**STAFF RECOMMENDATION**  
**1311 & 1313 2<sup>nd</sup> Avenue North**  
**May 15, 2019**

**Application:** New Construction—Additions  
**District:** Germantown Historic Preservation Zoning Overlay  
**Council District:** 19  
**Base Zoning:** MUN  
**Map and Parcel Number:** 08209022400, 08209022500  
**Applicant:** Clay Adkisson  
**Project Lead:** Sean Alexander, sean.alexander@nashville.gov

**Description of Project:** An application to rehabilitate two historic houses at 1311 and 1313 2<sup>nd</sup> Avenue North and to construct an addition that will connect them across the rear. The site is located within the East Development Zone of the overlay.

Enclosed side porch on 1313 2<sup>nd</sup> Ave N.

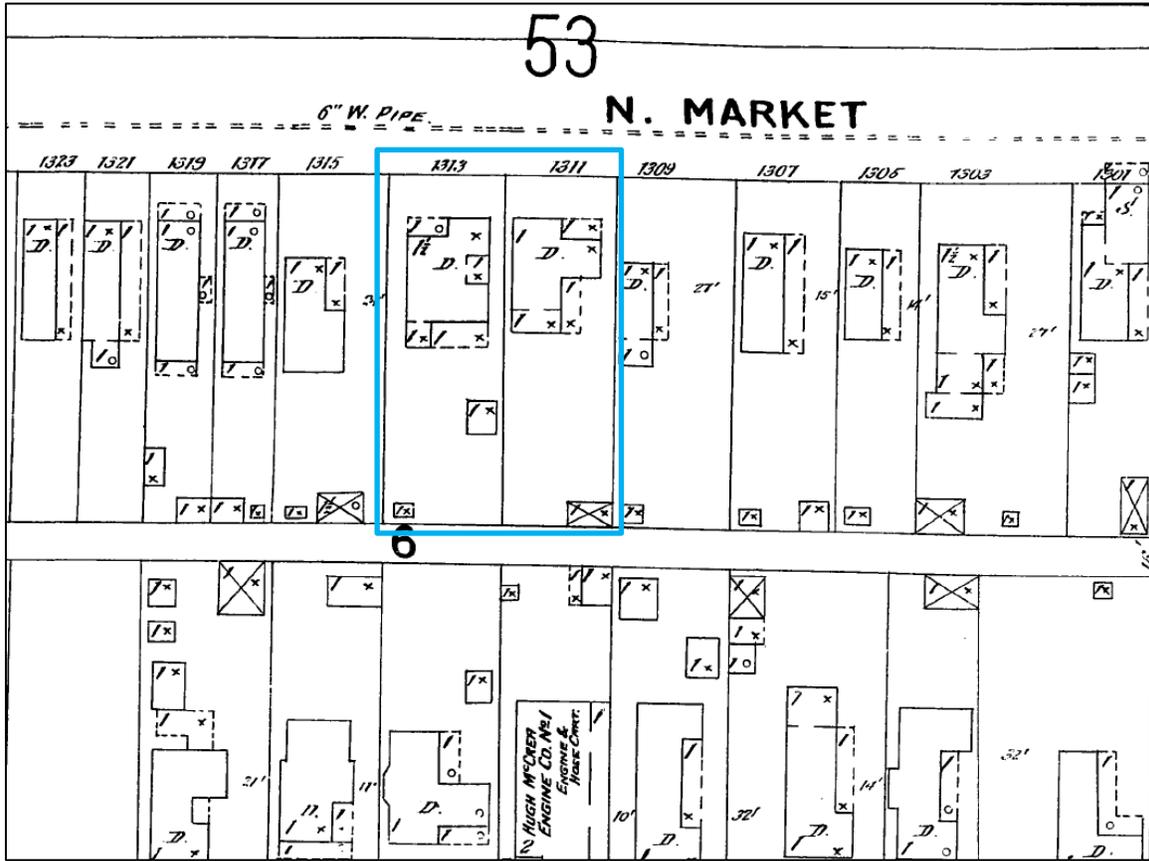
The project would also alter the outer wall of the original side porch of 1313 2<sup>nd</sup> Ave N which is currently enclosed with a T1-11 plywood siding. The applicant proposes to replace the plywood wall with brick to match the primary material on the house. Staff finds that removing the plywood siding is appropriate but that filling the porch opening in with brick would give the false appearance of being an original wall.
